FINAL PLAT

SMITHMOOR NINTH ADDITION TO WICHITA, SEDGWICK COUNTY, KANSAS

S/D 99-20 -- Final Plat of SMITHMOOR NINTH ADDITION

At the regular meeting of the Subdivision Committee of the Metropolitan Area Planning Commission on Thursday, April 22, 1999, the above captioned plat was considered. The action of the Committee was to approve the final plat subject to:

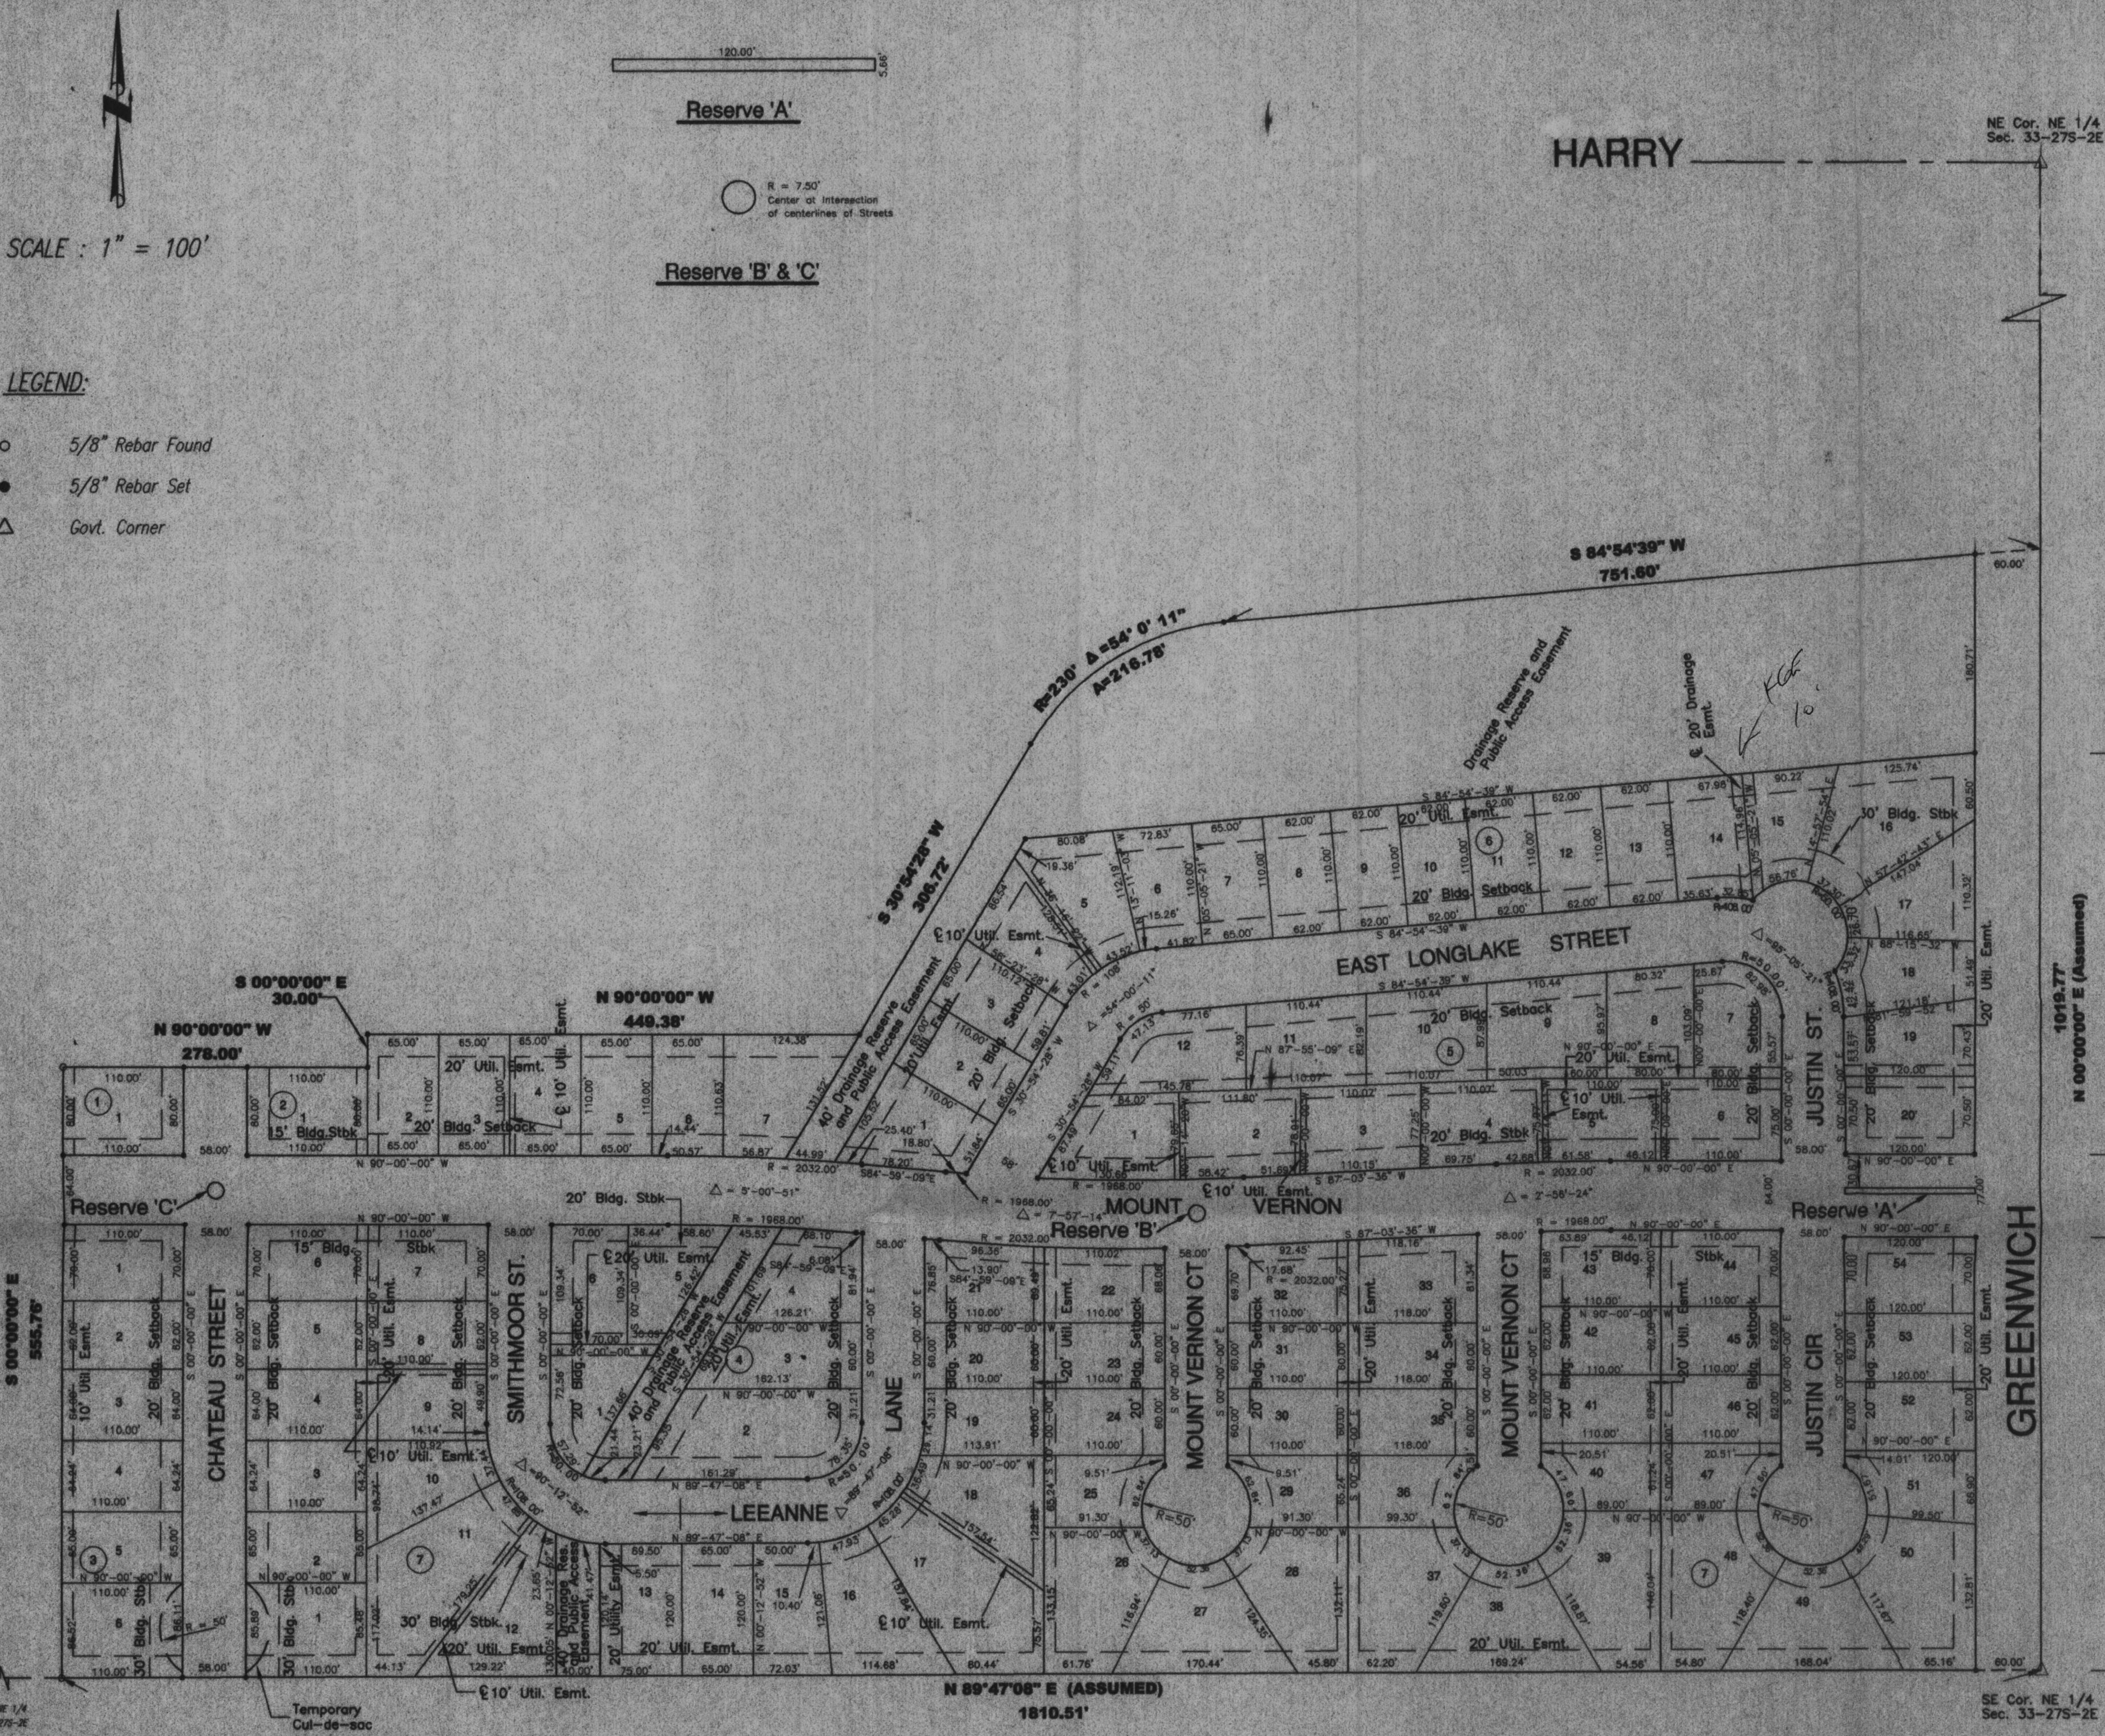
1. "Chateau Street" shall be extended to the south line of the plat.
2. Submission of the fully completed and signed tracing of the subdivision, along with four (4) copies, to the Metropolitan Area Planning Department.
3. Submission of a check, made out to the Register of Deeds, covering the costs of any documents to be recorded as a requirement of platting.
4. Subdivision regulations now require a detailed Lot Grading Plan be submitted to Engineering prior to the tracing being released. This applies to all multi-lot and residential developments.
5. Submission of a disk to the Planning Department detailing the final plat in digital format in Release 13 Version of Autocad. This will be used by the City and County GIS Departments.

- A. The applicant shall guarantee the extension of sanitary sewer to serve the lots being platted. This guarantee shall be with the County for service through the Four Mile Creek sanitary sewer system. On the final plat tracing, appropriate wording shall be added to the Mayor's signature block indicating the City's agreement to allow a County sewer district to be formed within the City.

- F. The applicant shall plat a reserve within the 77-ft right-of-way at the entrance to the site. The reserves shall be referenced in the plat's text.

- G. The tie points shall read, "27S".

sheet → K. City Fire shall comment on the street names. City Fire has requested new street names on the final plat. Longlake Street shall be designated as "E. Longlake Street". Chateau shall be designated as "Chateau Circle".

L. The legal description needs to be revised to eliminate the paragraph beginning with, "A tract of land located in the west half of the northeast quarter..."

M. The dimension denoted for the east line of the plat does not coincide with the distance identified in the platting binder.

N. On the final plat tracing, the year 1998 shall be replaced with 1999 on all certifications.

O. The MAPC Chair shall be identified as William M. Johnson.

P. The Parks and Pathways Plan has indicated that a recreation corridor should be provided along the south line of this plat. The Applicant should contact the Planning Department's Land Use staff to discuss issues involving the dedication of public access easements. The applicant shall dedicate a public access easement along the drainage reserve.

Q. The platting text shall include language that a drainage plan has been developed for the plat and that all drainage easements, rights-of-way, or reserves shall remain at established grades or as modified with the approval of the applicable City or County Engineer, and unobstructed to allow for the conveyance of stormwater.

The public access easement has been denoted on the final plat.
